**AMENDMENTS TO THE DRAWINGS**

**REMARKS**

**Amended FIG. 2(a)**

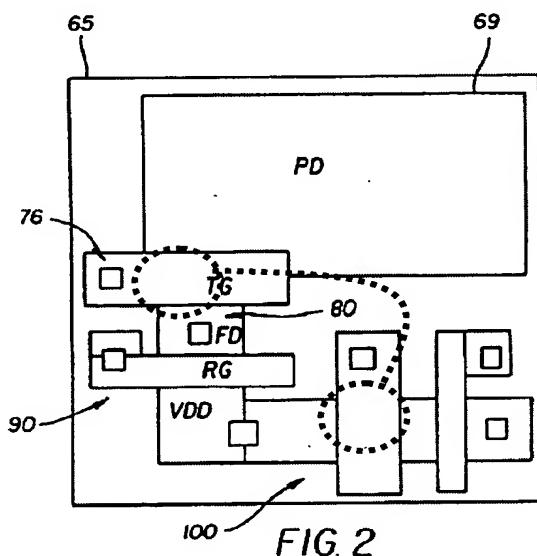
As was indicated in the Office Action (page 9) in relation to claim 40 (deemed allowable), independent claim 46 recites "said transistor also having a gate length which is greater than that of any other transistor of a same pixel." Such subject matter is not taught or suggested in the combination of references. Stevens et al. is relied upon in the Office Action (page 7) for such a disclosure; however, this is a misinterpretation of Stevens et al. As shown in FIG. 2 of Stevens et al. (reproduced below), the transistor in electrical contact with the photodiode (having gate 76) does not have a greater gate length than the other transistor gates of the pixel.

As highlighted (see dotted lines) in the reproduced figure above, at least one other transistor gate of the pixel of Stevens et al. has the same gate length as the gate for the transistor at the photodiode. Further, Stevens et al. does not indicate that the illustration of transistor gates in FIG. 2 are actually representative of the pixel's structure. For at least this reason, the combination of Stevens et al., Kuriyama et al. and Komuro would not have made the recited subject matter obvious. Applicant

FIG. 2(a)

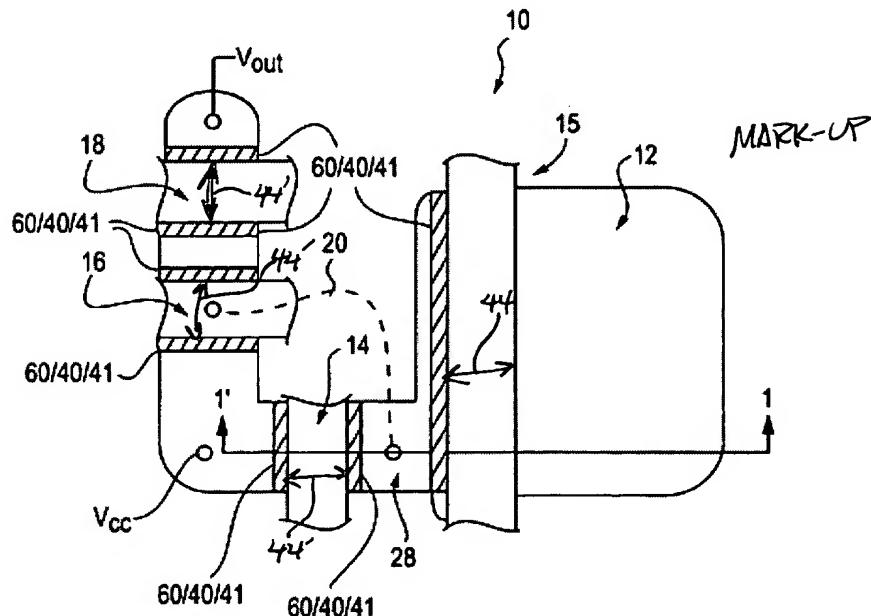
The drawings are objected to under 37 C.F.R. § 1.83(a) as allegedly not showing every feature of the claimed invention. FIG. 2(a) is amended, a replacement sheet is provided, as is a mark-up version showing changes in red ink.

The drawings stand objected to under 37 C.F.R. § 1.83(a) as allegedly not showing every feature of the invention claimed. FIG. 2(a) is amended to show how a transfer transistor can have a greater gate length relative to the other transistors of the same pixel. This subject matter is supported by the application as originally filed, at least at paragraphs 0028, 0033, 0040, and 0044, of the specification. The specification is amended to discuss reference numbers relating to gate length (i.e., 44 and 44'), which have been added to FIG. 2(a). The objection to the drawings is respectfully requested to be withdrawn.
